Access Compliance Report

Public Rights-of-Way

Intersection ID: N/A	Main Street: STEEL_CREEK_RD	Cross Street: SNOW_RIDGE_LN	Location: NW
ADA ID: 4193B5E08C30	Ramp Type: PerpDiag	Initial Pass/Fail: Fail	Overall Compliance: No
		Severity Score: 10

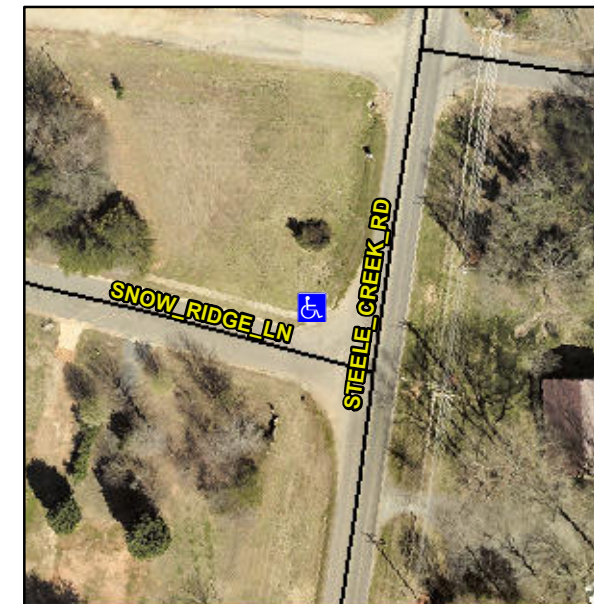
Not Found, R304.5.1, R304.5.3

Compliance	Description	Data	Compliance	Description	Data
N/A	Ramp Length (in)	48.0	Yes	Ramp Slope (%)	7.7
No	Ramp Width (in)	44.0	No	Ramp XSlope (%)	2.7
N/A	Flare Type LT	N/A	N/A	Flare Type RT	N/A
N/A	Flare Slope LT (%)	N/A	N/A	Flare Slope RT (%)	N/A
N/A	Flare Traversable LT?	N/A	N/A	Flare Traversable RT?	N/A
N/A	Landing Length (in)	N/A	N/A	DWS Provided?	N/A
N/A	Landing Width (in)	N/A	N/A	DWS Contrast?	N/A
N/A	Landing Slope (%)	N/A	N/A	DWS Length (in)	N/A
N/A	Landing X Slope (%)	N/A	N/A	DWS Full Width?	N/A
N/A	Landing Curb? (Y/N)	N/A	N/A	DWS Offset (in)	N/A
N/A	Shared Landing?	N/A			
N/A	Gutter Ponding?	N/A	N/A	Gutter Slope (%)	N/A
N/A	Gutter Lip Ht (in)	N/A	N/A	Gutter X Slope (%)	N/A
N/A	Painted X Walk1?	No	N/A	Painted X Walk2?	No
	X Walk 1 Direction	To S		X Walk 2 Direction	To E
N/A	X Walk 1 Width (in)	N/A	N/A	X Walk 2 Width (in)	N/A
	X Walk 1 Slope (%)	3.0		X Walk 2 Slope (%)	1.8
	X Walk 1 X Slope (%)	1.3		X Walk 2 X Slope (%)	1.2

Remove & Replace Curb Ramp With Two New Directional Ramps or Equivalent.
